## City of Phoenix

### **ADDENDUM A** **Staff Report: Z-45-25-1** **September 3, 2025**

The purpose of this addendum is to revise the site plan, elevations, and landscape plan submitted by the applicant, which includes a building at the southeast corner of the site and additional landscaping.

**PROJECT NAME:**  
EURO-STONE DESIGN, LLC  
Office Building/Distribution

A Building - East Elevation

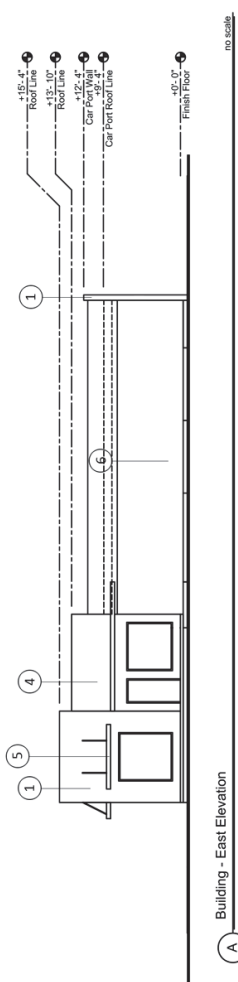
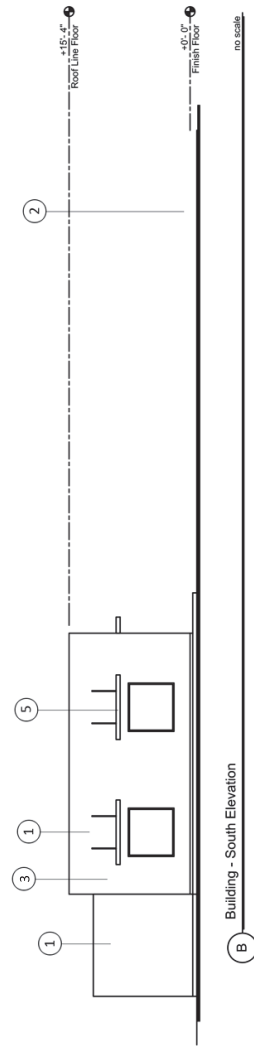
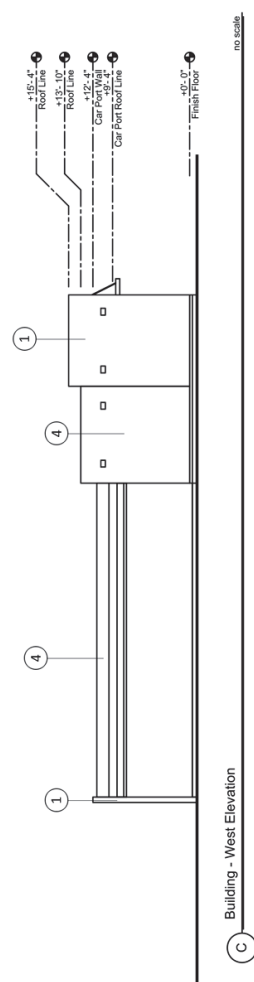
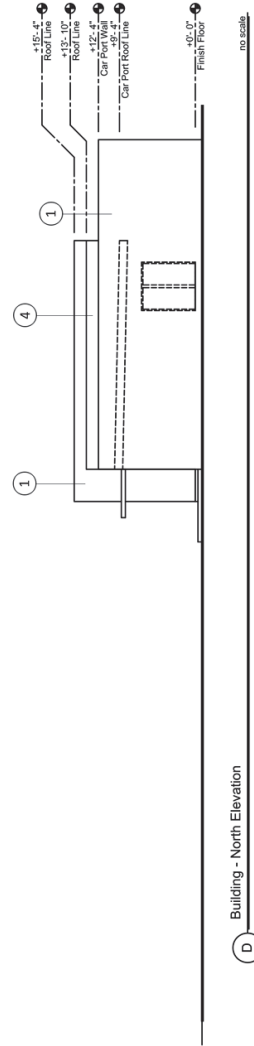
On August 18, 2025, the applicant submitted a revised site plan, elevations, and landscape plan. The revised site plan depicts an office building adjacent to Lone Cactus Drive. The elevations depict the height of the building as fifteen feet and four inches tall, made of stucco and stacked stone with a shade canopy. The landscape plan shows the proposed landscaping along 24th Avenue, Lone Cactus Drive, and along the west property line.
